Request for Additional Information 558(6720), Supplement 1

U. S. EPR Standard Design Certification

Review Section: 09.04.05 - Engineered Safety Feature Ventilation System

Question 09.04.05-5:**Open Item****Follow-up to RAI 509, Question 09.04.01-7**

Figure 15.0-12—Model for the Loss of Coolant Accident Analysis

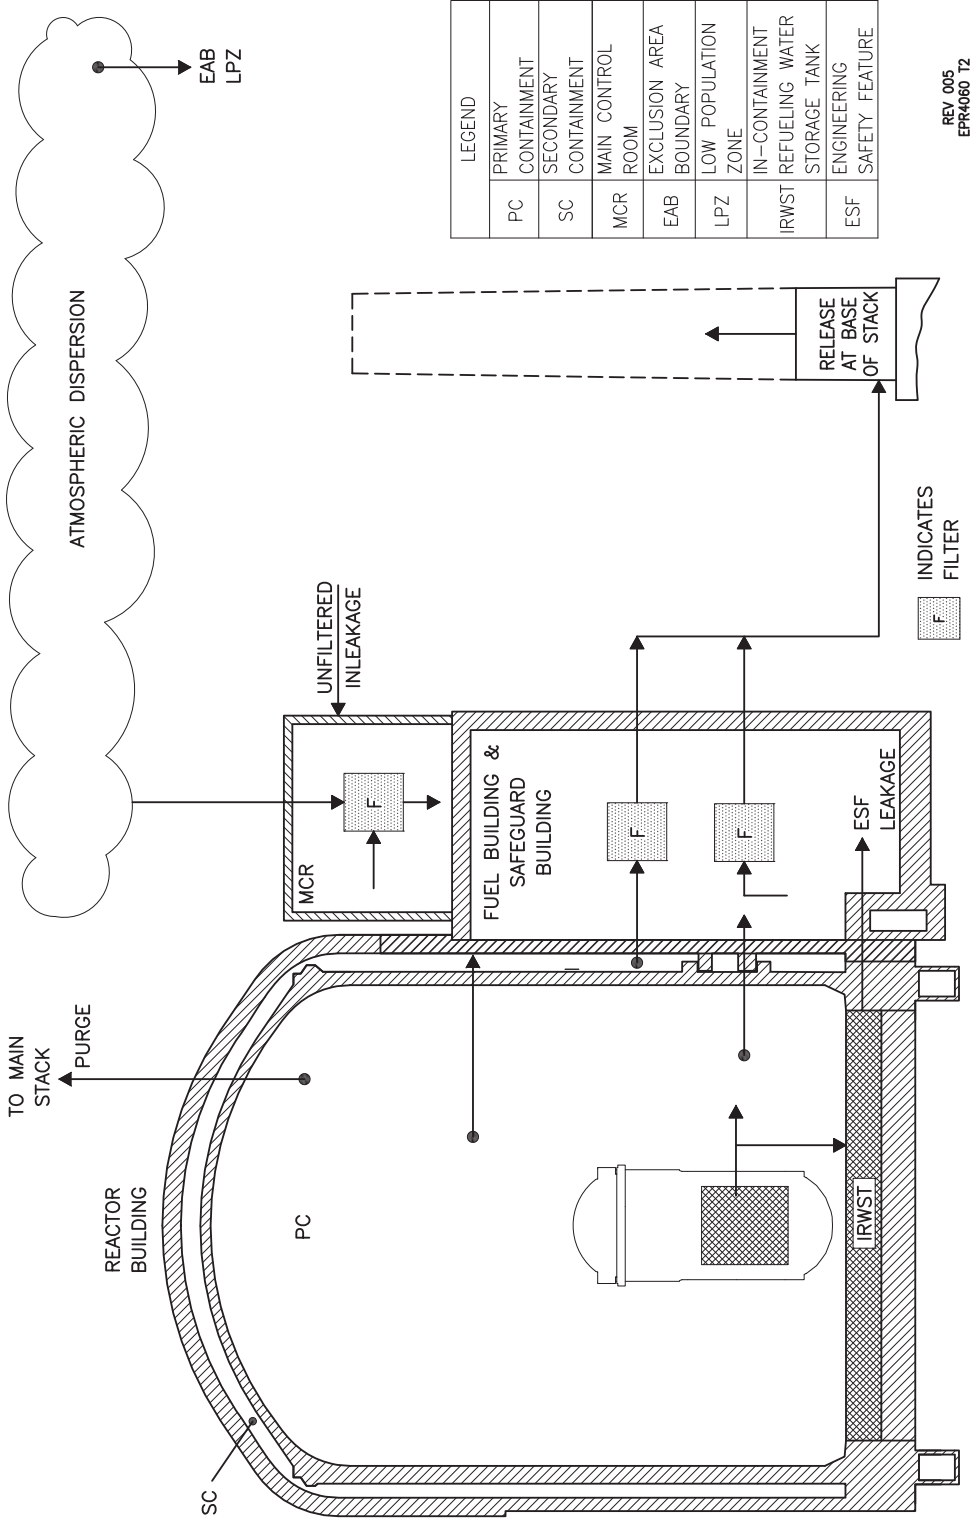
- U.S. EPR FSAR Tier 2, Figure 15.0-12–Model for the Loss of Coolant Accident Analysis, currently shows a filtered purge line between the primary containment and main stack. The purge line does not contain a filter. This figure will be revised to reflect the correct design configuration.

U.S. EPR FSAR Tier 2, Figure 15.0-12, Table 15.0-42, Table 15.0-51, and Chapter 16 will be revised as described in the response and indicated on the enclosed markup.
